Adamstown Boulevard

Phase 1 Road Safety Audit

Adamstown Station & Boulevard Ltd

April 2022

Figure 2-1 – No Pedestrian Crossing Provision

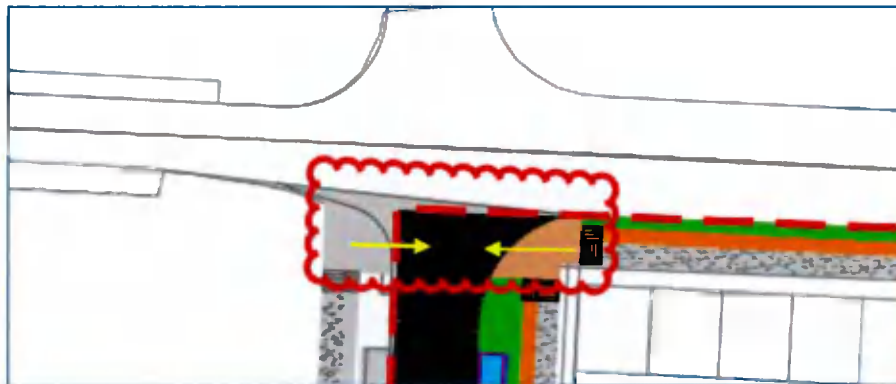
There is no crossing provision for pedestrians trying to cross East – West at the location shown in Figure 2-1. This may lead to pedestrians trying to cross the road in a location which is unsafe to do so and may result in them being struck by a vehicle.

The designer should provide appropriate crossing facilities for pedestrians to cross at the junction.

Paragraph No. in Safety Audit Report	To be completed by the Designer			To be completed by the Audit Team
	Problem accepted (yes/no)	Recommended measure accepted (yes/no)	Alternative measures (describe)	Alternative Measures accepted by Auditors (yes/no)
2.1	Y	Y		
2.2	Y	Y		
2.4	Y	Y		
2.5	Y	Y	Parking to be adjusted to take account of appropriate visibility splay for the design speed of the road in accordance with DMURS	
2.6	Y	Y	Demand for crossing to be assessed an if required appropriate crossing provision provided.

Figure 2-3 – Location where Pedestrians Enter Shared Area

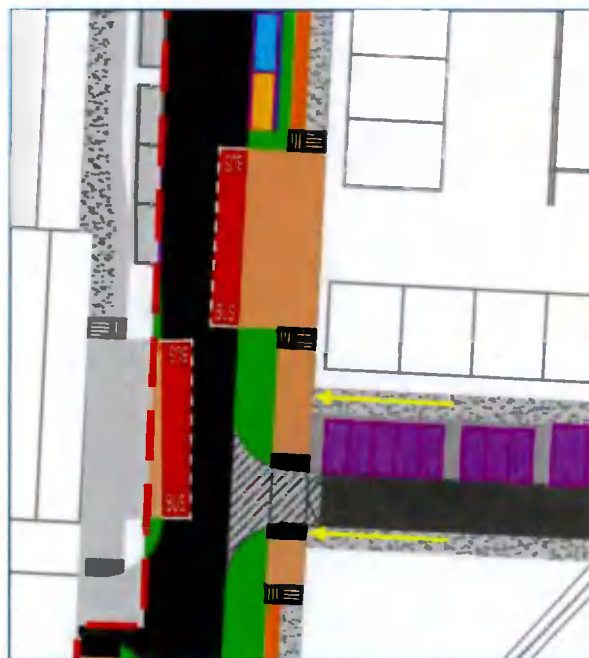
Figure 2-3 shows an example of a location where pedestrians could enter a shared area without being aware it is shared.

The designer should ensure that all shared areas are denoted correctly for both cyclists and pedestrians with a consistent approach provided across the scheme.

Figure 2-4 – Example of Grass verges Separating Footpath and Parking Bays

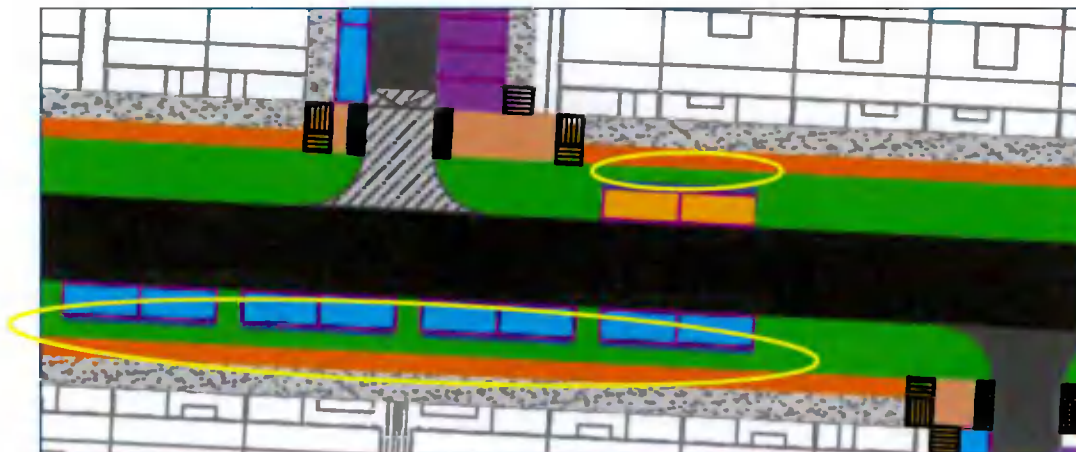
The proposed scheme shows parking bays which are separated from the footpath with a grass verge as shown in Figure 2-4. This could lead to pedestrians slipping and falling on the grass particularly in wet conditions or pedestrians may be forced to use the carriageway to access the parking spaces and possibly result in them being struck by a vehicle.

The designer should ensure that safe access to all parking areas is provided throughout the scheme.

Figure 2-5 – Signalised Junction No.1

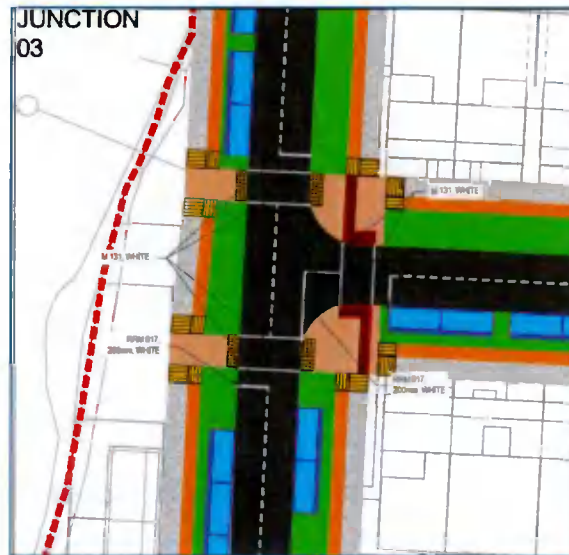
The proposals indicate courtesy crossings on the main north-south streets for the scheme. It appears unlikely that these will adequately allow for safe crossing of these roads and may lead to conflict with pedestrians and vehicles. Additionally the side road shows a controlled crossing, drivers may move on a green signal on the side road and enter the main road when it is unsafe to proceed. This may lead to shunt and side-impact conflict.

The designer should review the junction strategy ensuring these will cater for the likely demand, provide adequate control and not lead to potential confusion for both pedestrian and vehicles users.
